City of Hutto

Planning and Zoning Commission

Tuesday, June 6, 2023 at 7:00 PM

RE: Lidell Walker Phase 1 Final Plat, Hutto, TX 78634
Final Plat Review – Lidell Walker Phase 1 Final Plat - Comment Report to Update #1 Submittal (received 5-8-23)
Project No.: 2057-PLAT

HEC-RAS Plan: Ult_v1 River: Mustang Creek Tr Reach: FLOWLINE Profile: PF 1

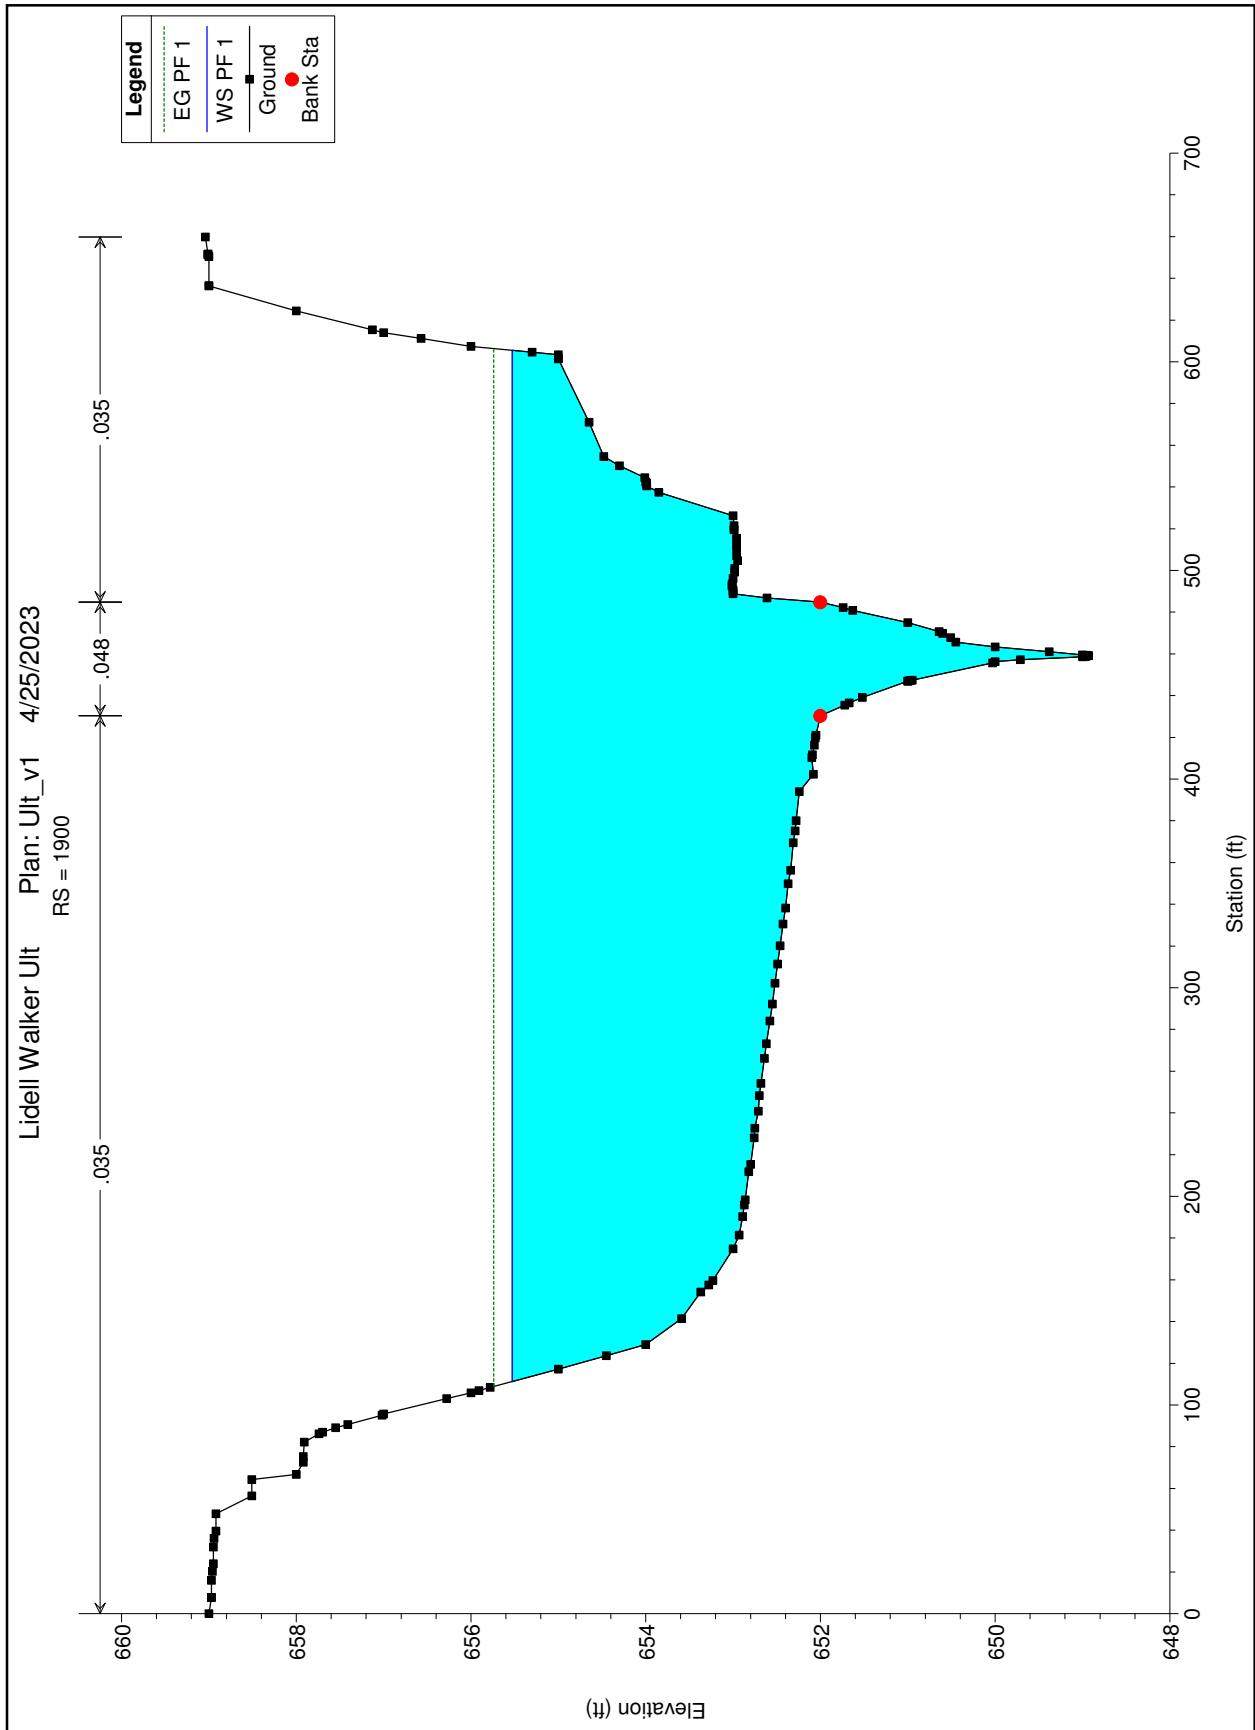
based on the drainage area maps there should be a flow change at station 200, 800, 1300, and 1800. according to the HMS analysis the final flow should be 4827.60.

Soil Map

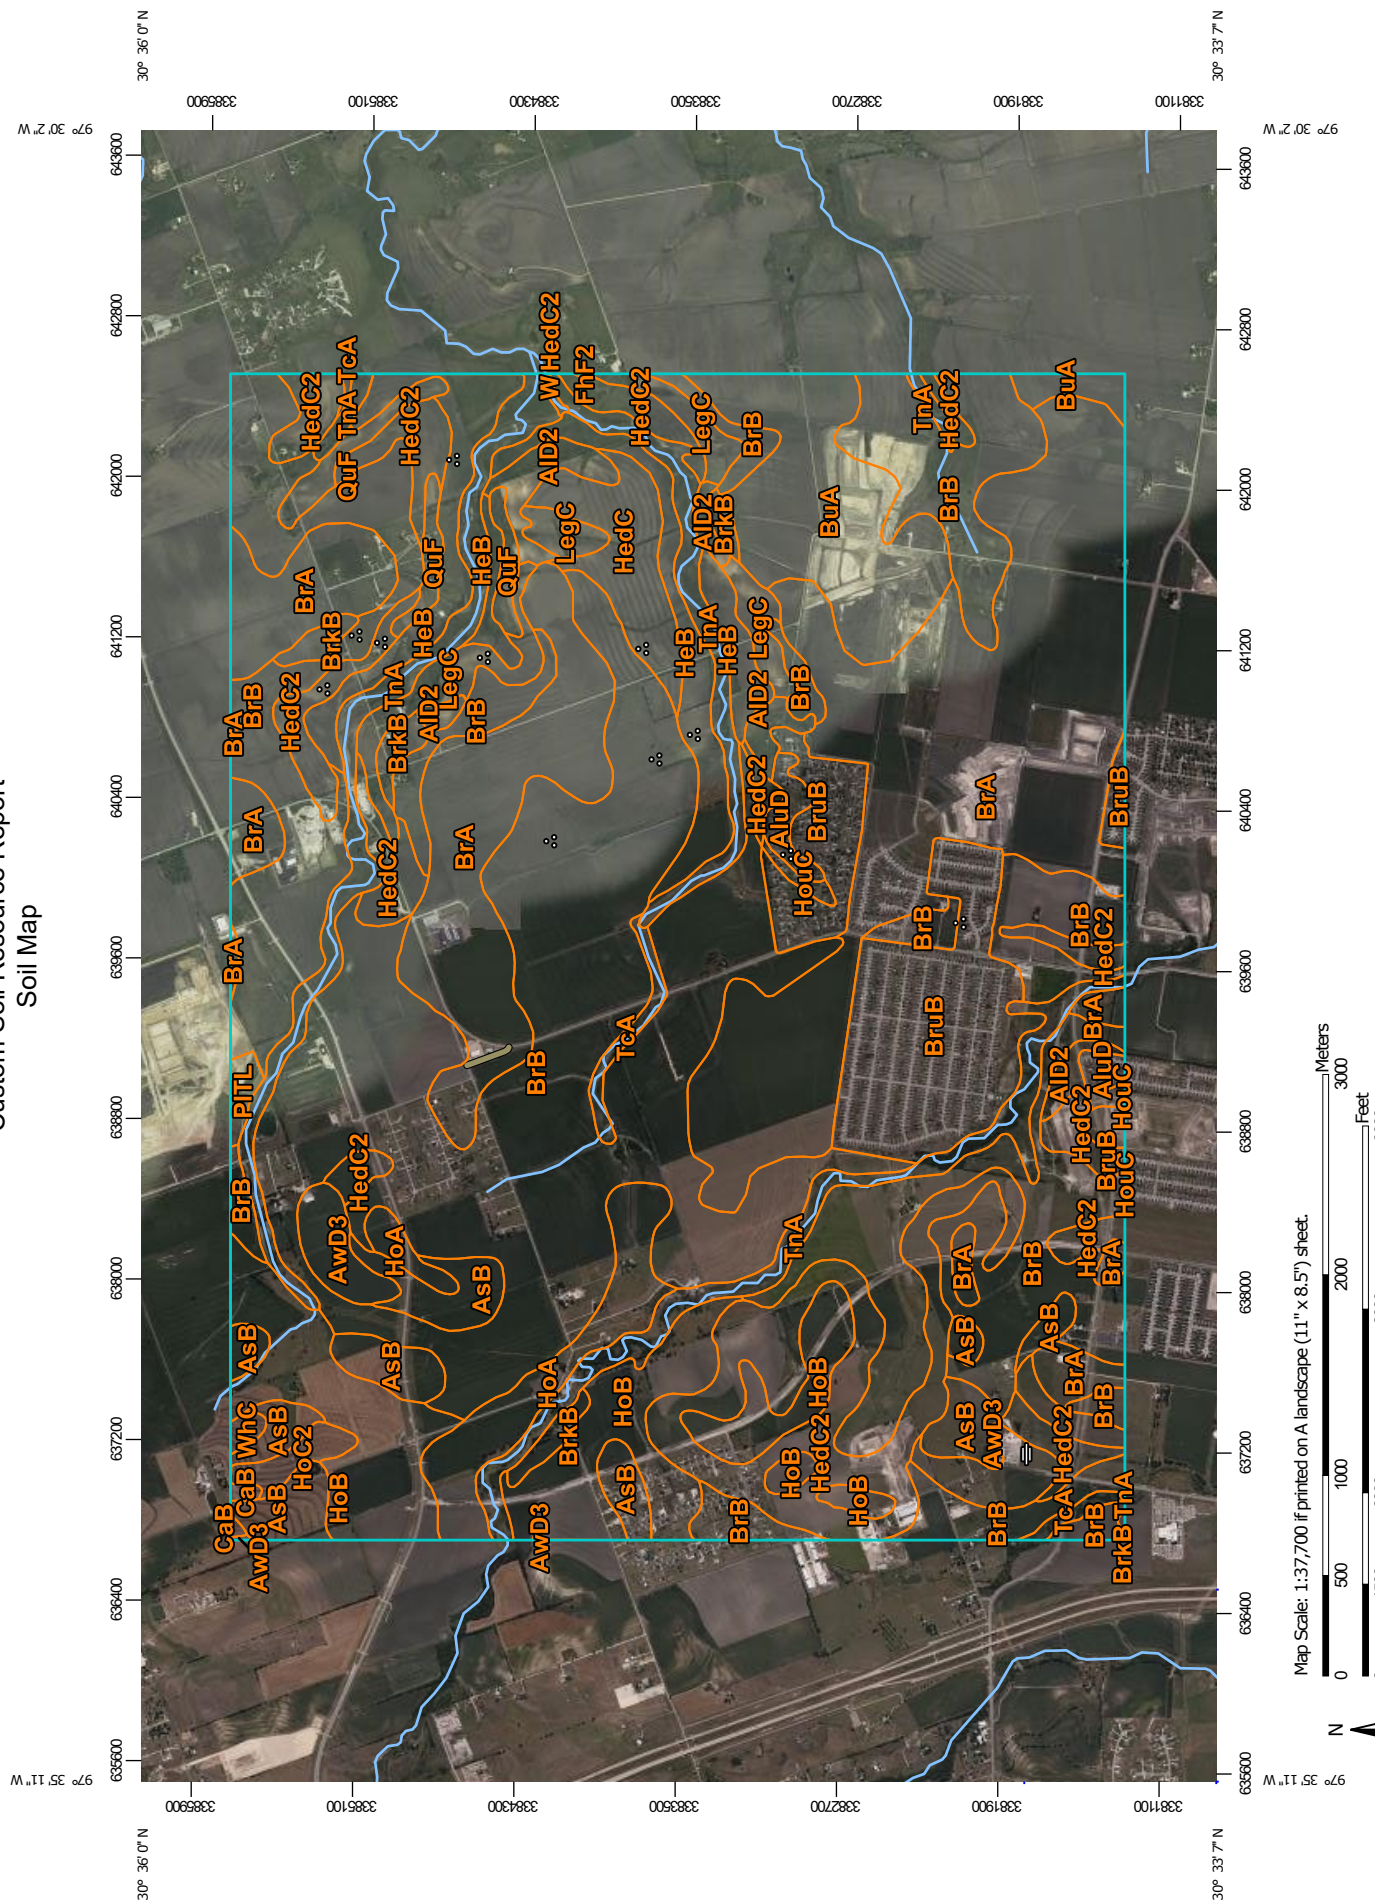
there are no row
crops in the DACS
please verify that all
CNs have been done
per the DAGs
